**NSLPP MEETING HELD ON 14/09/2022**

**ADDRESS/WARD:** 1-7 Rangers Road & 50 Yeo Street, Neutral Bay

**PROPOSAL NO:** 6/22

**PROPOSAL:** To amend North Sydney Local Environmental Plan (NSLEP) 2013 as follows:

**FIGURE 30: Proposed Massing Diagram (Applicant's Urban Design Report, p. 28)**

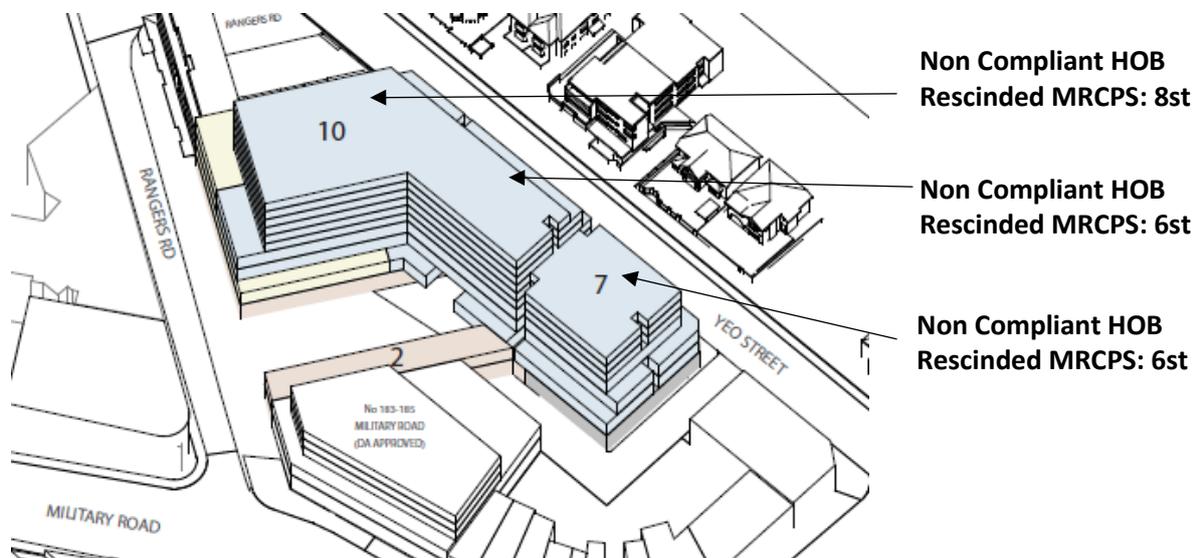
The proposed 10-storey height along Rangers Road and Yeo Street does not provide a human-scale frontage to the plaza nor an appropriate transition in height and scale to surrounding low-scale residential areas to the south. The proposed height and continuous length of the building along Yeo Street results in a 'long and tall' barrier between the proposed plaza and residential dwellings along Yeo Street (refer to Figure 31).

In addition, the requested height of 40m and 30m appears excessive for the number of storeys and could potentially result in a building greater than 10-storeys and 7-storeys respectively across the site.

The applicant's architectural drawings show floor-to-floor heights within the podium well in excess of that required to be provided for commercial spaces (typically 3.7m) and residential spaces (typically 3.1m). In particular, the following floor-to-floor heights are considered excessive and could be reduced:

**FIGURE 32: Applicant elevation plans – Yeo Street**  
(source: Applicant’s Architectural Plans, p. 20)

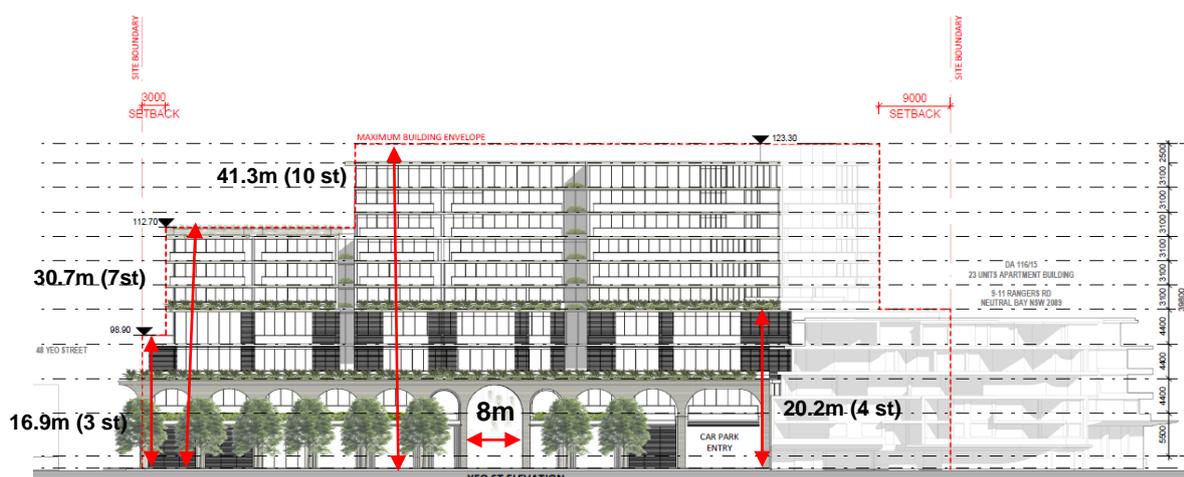
The applicant’s architectural plans show an indicative 4-storey podium to Rangers Road and Yeo Street, 3-storey podium to Military Lane and 2-storey podium around the plaza. For the reasons outlined in section 8.4 of this report, the proposed podium heights are considered excessive for the number of storeys and could be reduced.

The proposed podium height of 16.9m for 3 storeys fronting Military Lane is excessive and equivalent to 4-storeys. The proposed podium height of 9.9m for 2-storeys around the plaza could also be reduced to provide a more appropriate scale.

**FIGURE 33: 9-11 Rangers Road - Top view**

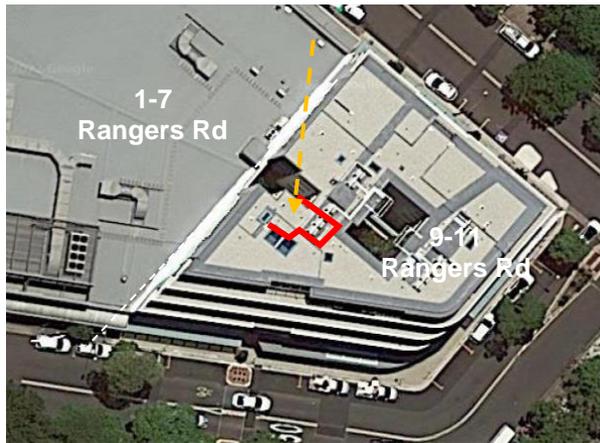
The applicant’s reference scheme shows residential apartments with habitable rooms and balconies above the podium (5-10 storeys) along the eastern boundary. SEPP 65 and the associated ADG requires a minimum 9m setback at 5-8 storeys and 12m setback at 9-10 storeys. The applicant’s reference scheme only provides a 9m setback from 5-10 storeys.

Whilst it is noted that the majority of the adjacent building façade at 9-11 Rangers Road is a blank wall, there is a small internal courtyard along the joint boundary which provides solar access to apartments within the development (refer to Figures 33-34). A 10-storey building height with non-compliant building separation at the upper levels (9-10 storeys) will result in unacceptable amenity impacts (solar access) to adjacent apartments.

**FIGURE 36: Applicant shadow diagrams (source: Applicant's Architectural Plans, pp. 29-30)**

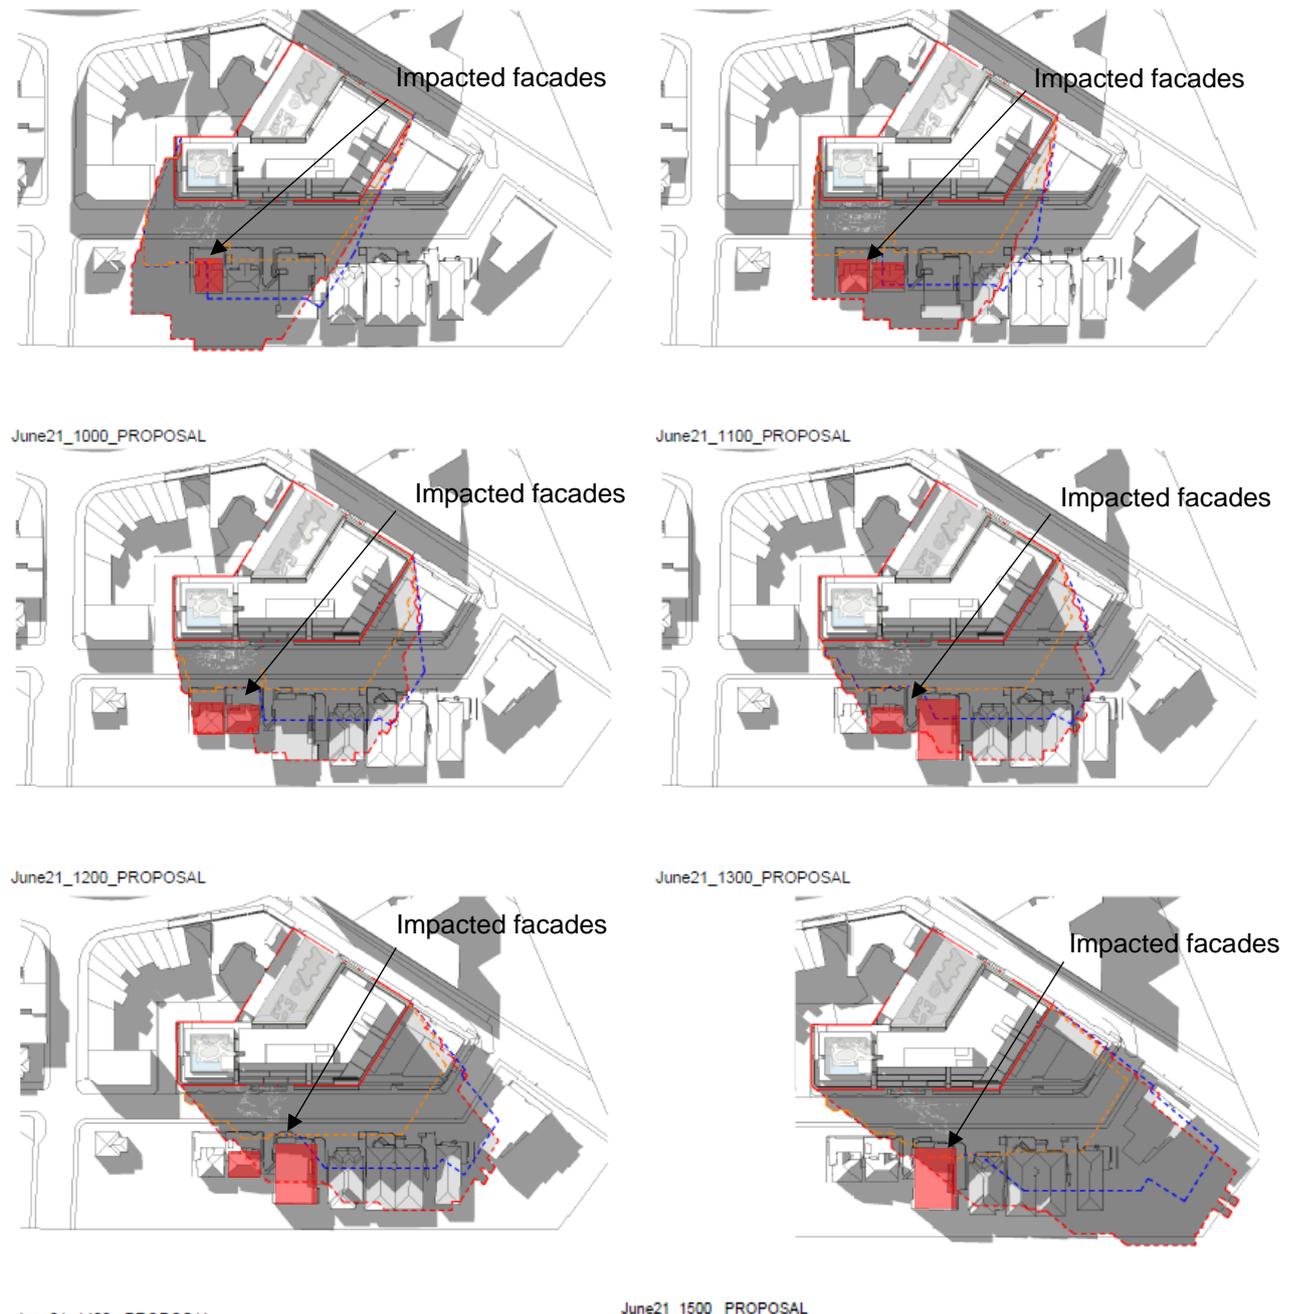
The applicant's shadow diagrams (refer to Figure 36) clearly indicate that the proposal will result in a significant reduction in solar access to residential dwellings on the southern side of Yeo Street between 10am to 3pm in mid-winter. The overshadowing impacts of the proposal are evidently greater than that contemplated under the rescinded MRCPS.

The justification provided by the applicant for the proposed impact is that for the most part, the additional shadows caused by the proposal only falls on rooftops and that shadows are already partially cast by high fencing and street canopy. This justification is immaterial and not accepted. It is evident from the analysis submitted, that existing levels of solar access to the primary living areas, balconies and bedrooms of predominantly north facing dwellings will be significantly reduced and to some dwellings (57-59 Yeo Street) will be in shadow for the entire day, contrary to the objectives and outcomes of the rescinded MRCPS.

It should also be noted that there is an error or misrepresentation in the applicant's shadow diagrams. The rescinded MRCPS recommended a 6m wide open-to-sky pedestrian through-site link along the western boundary of 1-7 Rangers Road which is not included. Therefore, the shadow impacts resulting from the rescinded MRCPS should be less than what is indicated in the diagrams below.

**FIGURE 37: Applicant shadow diagrams of proposed public plaza between 9am-4pm, 21 June.**  
 (source: Applicant’s Architectural Plans, p. 42)

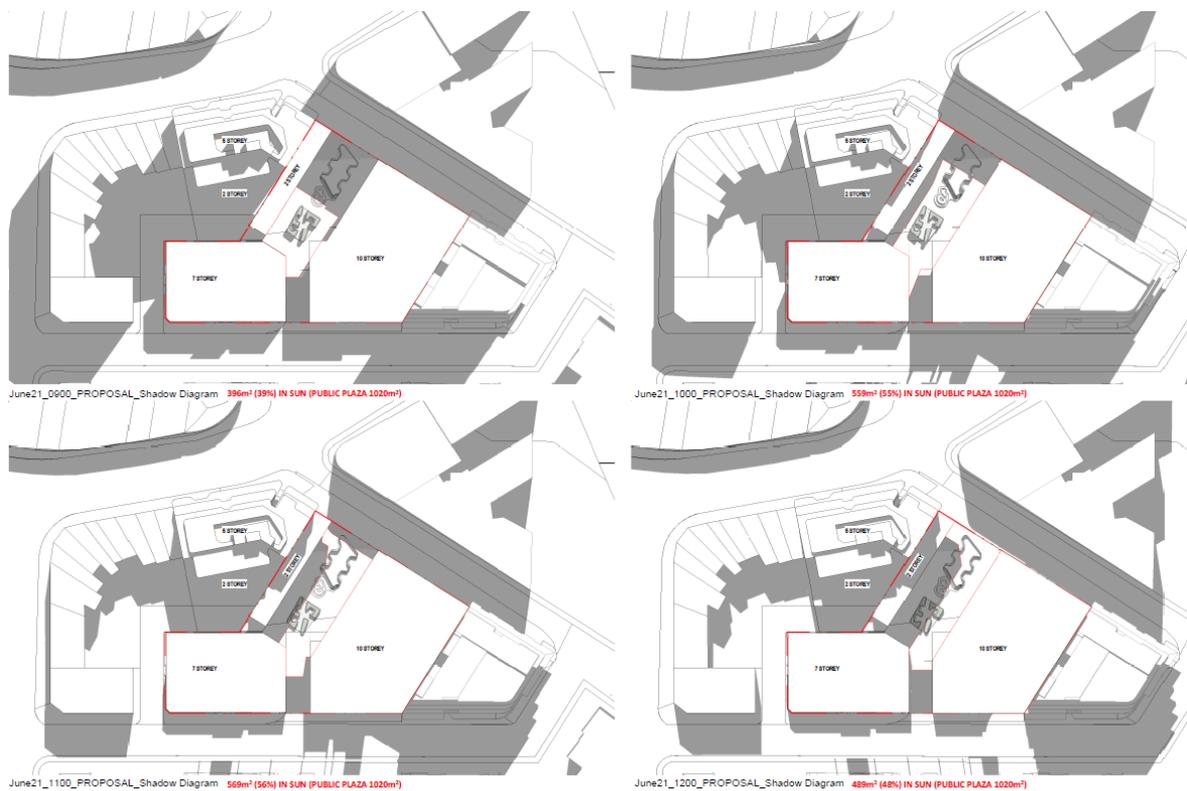
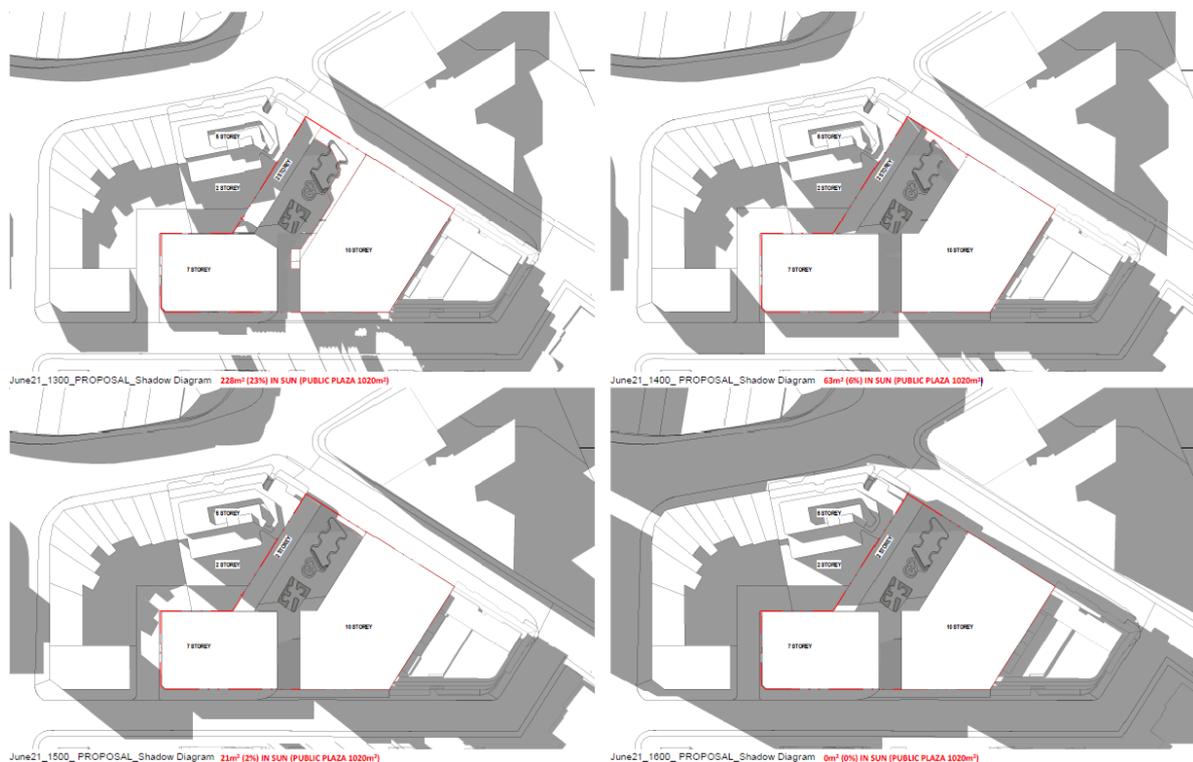
The applicant's shadow diagrams indicate that the Planning Proposal and approved DA at the 'Equitibuild' site would provide limited solar access to the public plaza, particularly between 1-4pm in mid-winter when the public space is likely to be most used. Between 10am-12pm in mid-winter approximately 50% of the plaza would receive solar access. At 1pm, solar access is reduced to 23%. From 2pm, solar access is further reduced to 6% and 2% at 3pm. At 4pm, the plaza is completely in shadow (refer to Figure 37).

As shown in Figures 38-39 below, a ‘compliant’ scheme under the rescinded MRCPS would enable 80% of the public plaza to receive solar access at 10am in mid-winter, compared to 50% under the applicant’s proposed scheme.

**FIGURE 40: Applicant landscape plan for proposed plaza  
(source: Applicant's Urban Design Report, p. 38)**

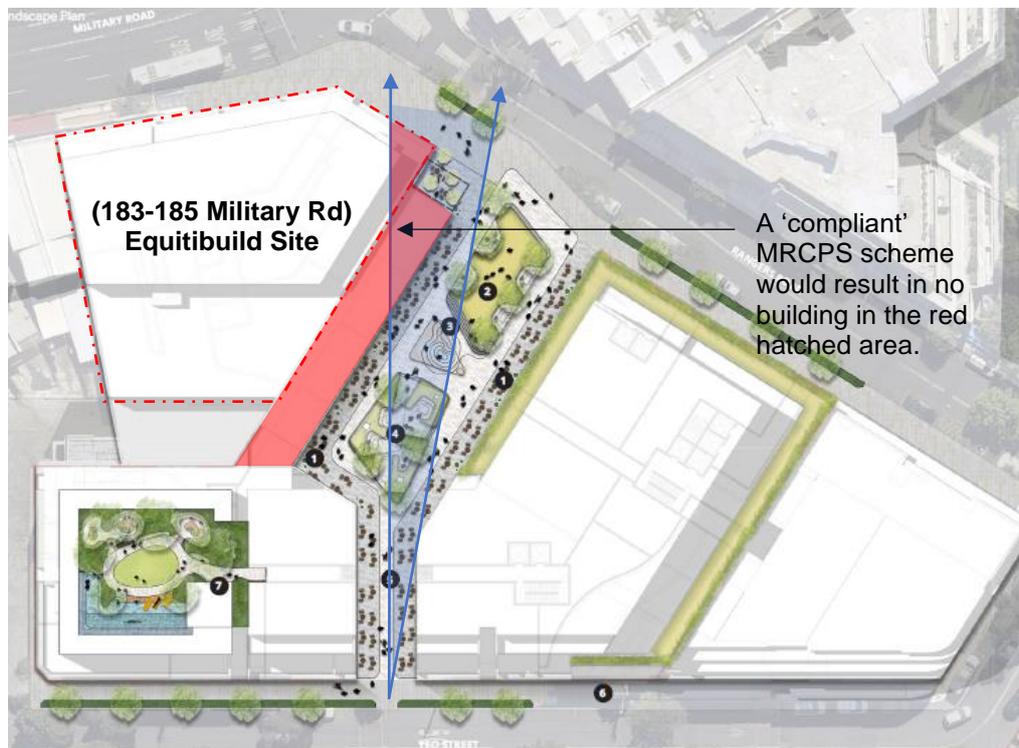
Whilst a renewed Study is still in progress, the proposal in its current form may, limit the development potential of the adjoining 'Equitibuild' site (which had been identified as suitable to accommodate some increased height and density) and potentially undermines the ability to leverage community benefits and public domain improvements from any future potential growth on that site. By proposing a narrow, two-storey retail strip on the joint northern boundary, the proposal prevents consideration of a genuinely 'public,' high-amenity plaza and the potential for the 'Equitibuild' site to provide a community facility fronting directly onto, and better activate, the public plaza.

The proposed retail strip has a narrow building depth of approximately 4-6.3m which limits the flexibility of use of these spaces. In addition, it results in a narrow and poorly connected plaza. As shown in Figure 40, the proposed plaza is oriented perpendicular to Rangers Road, away from Military Road intersection as the proposed two-storey retail strip along the northern boundary pushes the plaza further east and does not deliver a successful arrival point to the plaza from the Military Road intersection. It also blocks the envisaged connection between Military Lane and the new plaza and undermines the opportunity to potentially upgrade this connection and improve accessibility to the plaza.
